SITE PLAN
2260 ANDES WAY
AURORA, CO 80011

TARAHUMARA TRUCKING
 PHASING PLAN
 2260 ANDES WAY
 AURORA, CO 80011

JOB NO	954-1
CAD NO	954-1
DATE	03/30/23
UTILITY PLAN	2260 ANDES WAY AURORA, CO 80011

TARAHUMARA TRUCKING
 PHOTOMETRICS
 2260 ANDES WAY
 AURORA, CO 80011

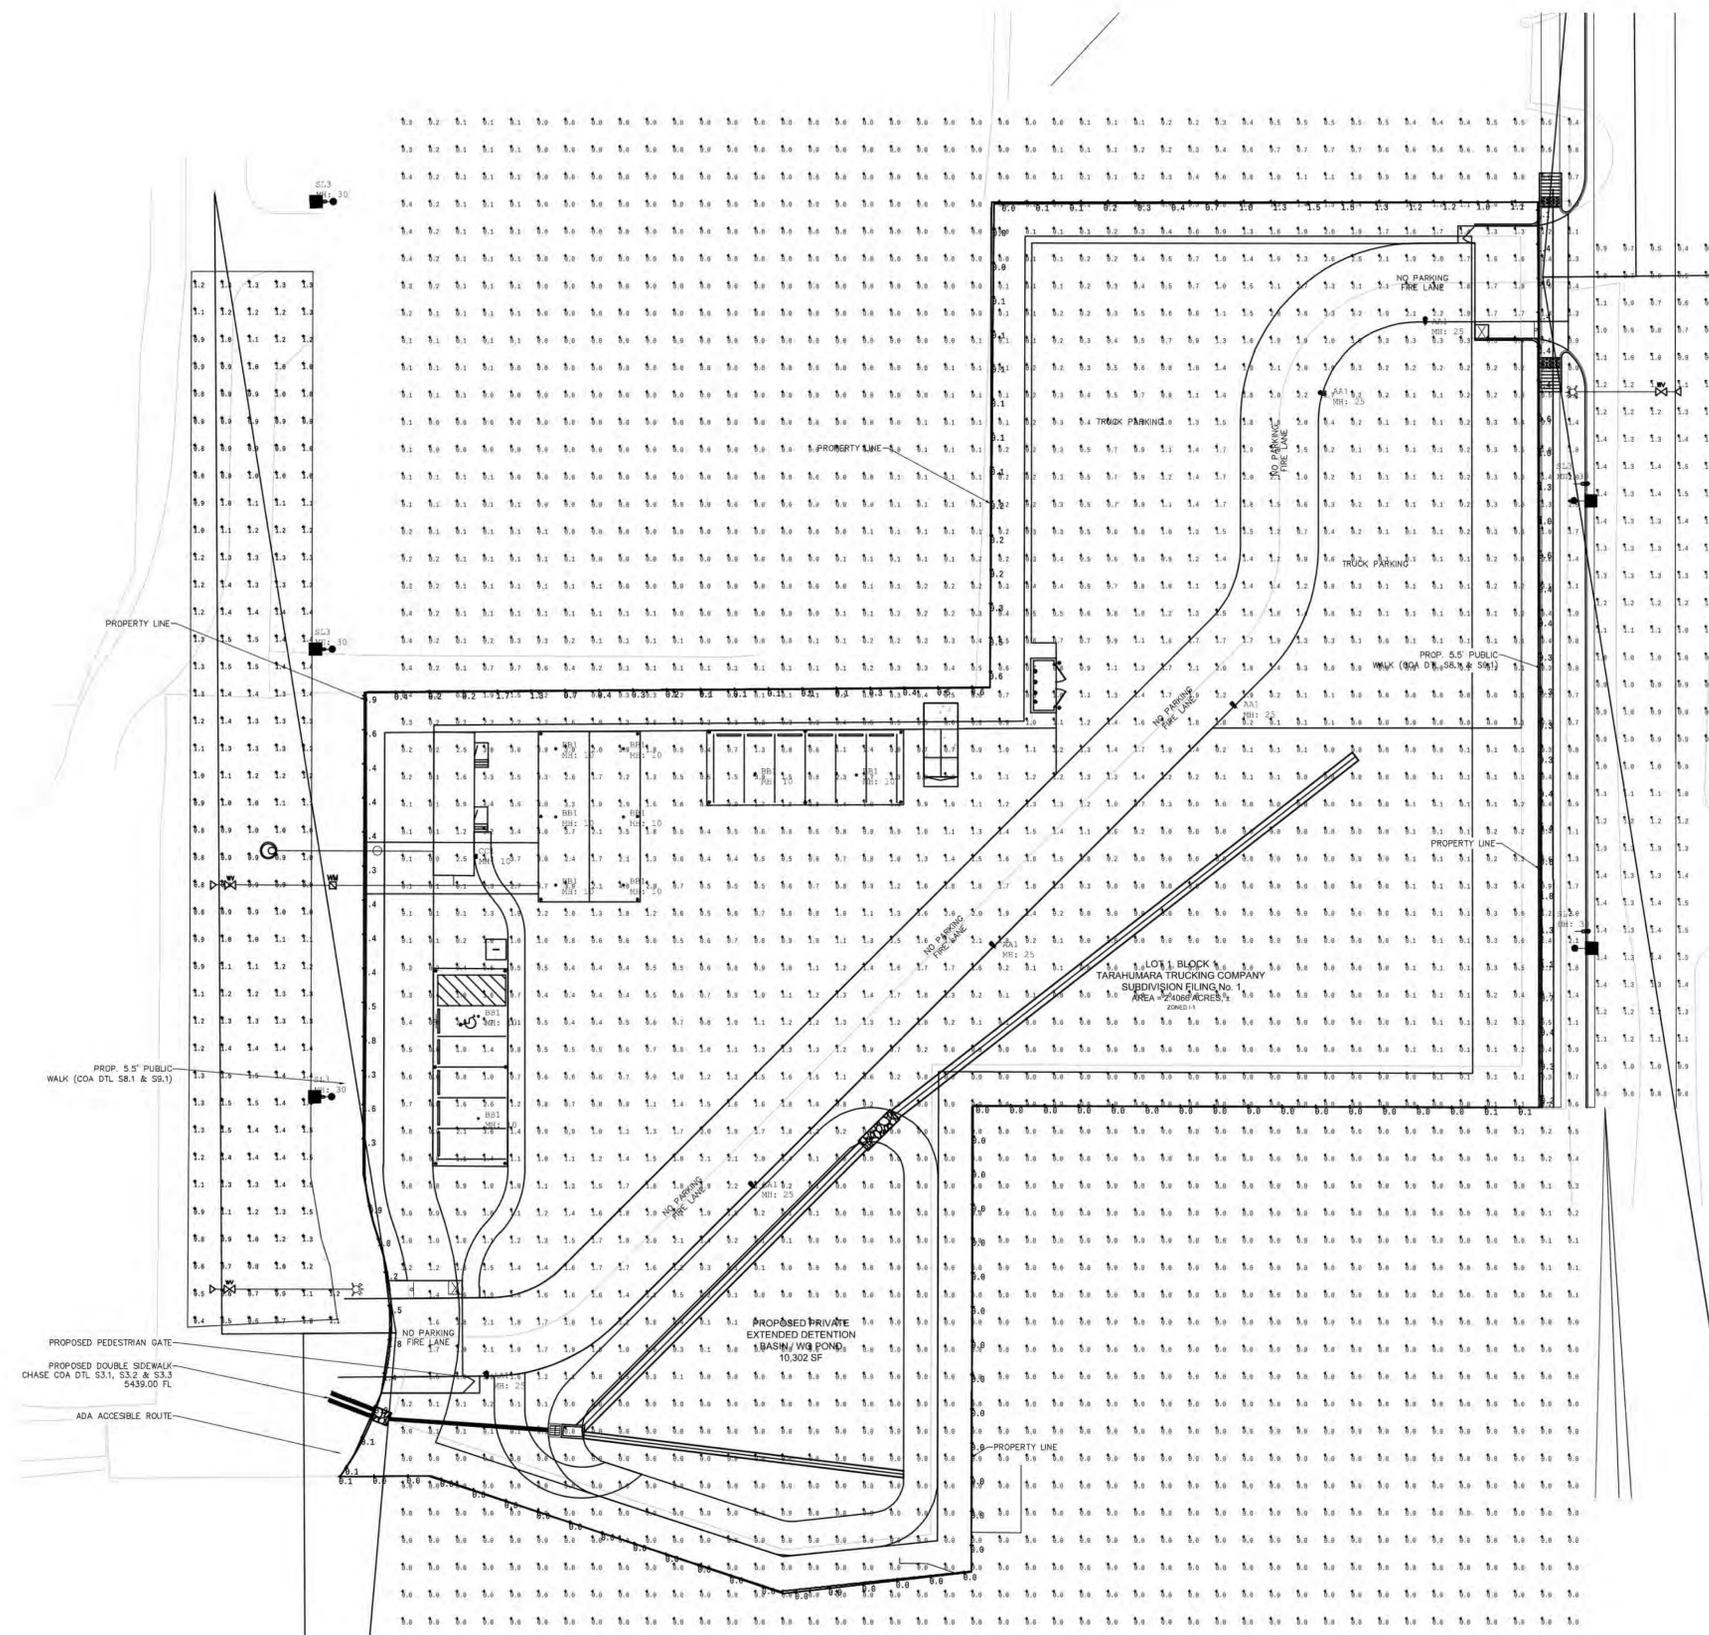
Please include all missing criteria required on site plans for lighting per section 2.12.0.1

2.12.0.1 The following criteria and note for each proposed roadway or portion of a roadway with differing criteria within a plat/development shall be identified, reviewed, and approved by the Public Works Department as part of the Planning Review Process (site plan) prior to performing lighting design and submitting the street lighting plan.

- Roadway Classification (typical section name)
- Adjacent Land Use Category (i.e., TOD), as applicable
- Number of lanes
- Back-sloped curb width
- Pedestrian Activity Level
- Pavement Type: R3, for all lighting calculations

Show the accessible route to the accessible parking by heavy dashed line. Verify minimum 1 foot-candle of illumination along its entire length.

Add the following note to the Photometric Site Plan: ILLUMINATION WITHIN THE SITE MUST COMPLY WITH THE 2015 INTERNATIONAL BUILDING CODE REQUIREMENT FROM SECTION 1006 - MEANS OF EGRESS ILLUMINATION. SECTION 1006. ILLUMINATION REQUIRED: THE MEANS OF EGRESS, INCLUDING THE EXIT DISCHARGE, SHALL BE ILLUMINATED AT ALL TIMES THE BUILDING IS OCCUPIED. SECTION 1006.2 ILLUMINATION LEVEL. THE MEANS OF EGRESS ILLUMINATION LEVEL SHALL NOT BE LESS THAN 1 FOOT-CANDLE (11 LUX) AT THE FLOOR LEVEL, AND CONTINUING TO THE "PUBLIC WAY".

Please add the following note: "Proposed street light locations are conceptual. Final locations will be determined with photometric analysis submitted with the street lighting plans in the civil plan submittal."

-Add light pole detail, including height

Advisory comment: Public street lights will be required to be submitted with a photometric analysis during the civil plan review process and lighting submittal must match one of the current pre-approved public street lighting equipment list. (ALL)
